**RE: Clarification regarding Condition of Approval #8 of the Traffic Study and Addendum for  
The Two Fifty, SDR-62393 & DIR 63602, T64341**

The Transportation Engineering Division has reviewed and approved the traffic study and addendum for The Two Fifty, to be located on the southwest corner of Alta Drive and Rampart Boulevard. Per this study, the project is proposed to consist of 60 single-family detached dwelling units (SFDUs) and 3,020 multi-family dwelling units (MFDUs). Condition #8 states:

**RE: Traffic Study and Addendum for The Two Fifty, SDR-62393 & DIR 63602, T64341**

**THE TWO FIFTY**

Figure 18. Background-Plus-Project – PM Peak Scenario 1

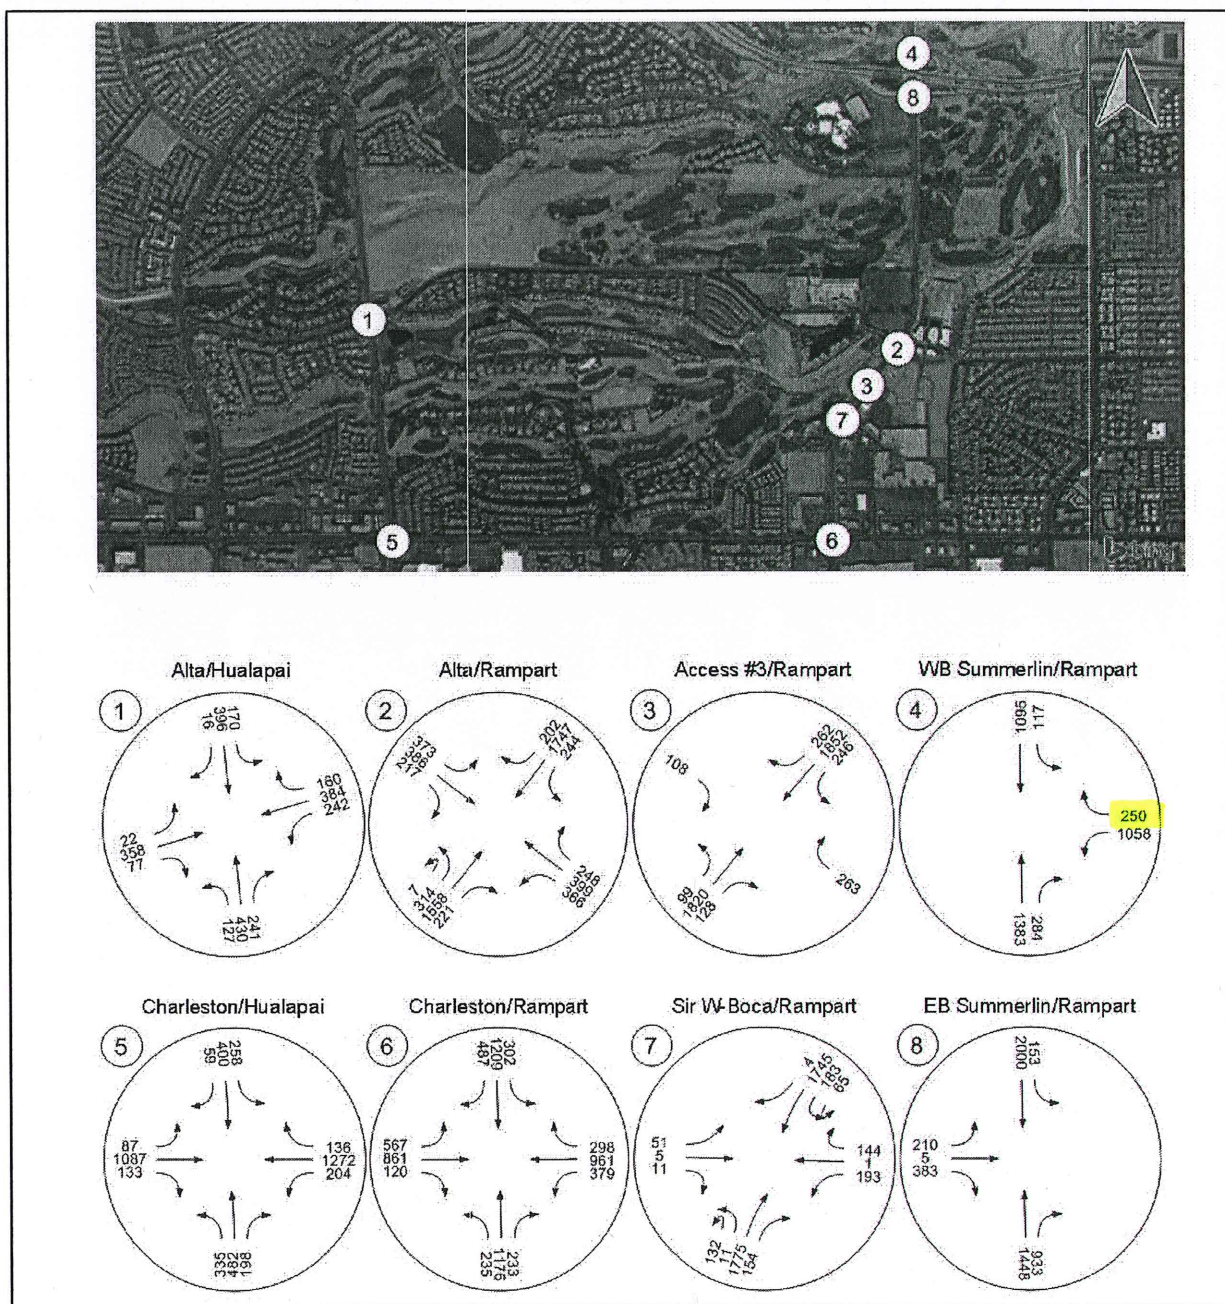
**Comment:** "1. On Figures 17 and 18, Background-Plus-Project AM and PM peak Scenario 1, the westbound left turning volumes for intersection 4 (Westbound Summerlin Parkway and Rampart) were left off.

**Response:** Please find revised Figures 17 and 18 attached. Westbound *right-turning* volumes have been added (169 vph in the AM peak hour and 250 vph in the PM peak hour).

**Comment:** "2. On Figure 18, Background-Plus-Project PM peak Scenario 1, the following volumes appear to be in error:

2. On Figure 18, Background-Plus-Project PM peak Scenario 1, the following volumes appear to be in error:
  - a) Intersection 11 (1st ES DW S-O W/Rampart), westbound rights shown as 1928; should be 1916.

**Response:** Please find corrected Figures 10, 11 and 13 for background traffic attached. The change in left-turn and U-turn access was assumed to have a minor impact on the distribution of background right-turn demands. The corrected volumes added to Figure 16 trip assignments yields the Figure 18 volumes.
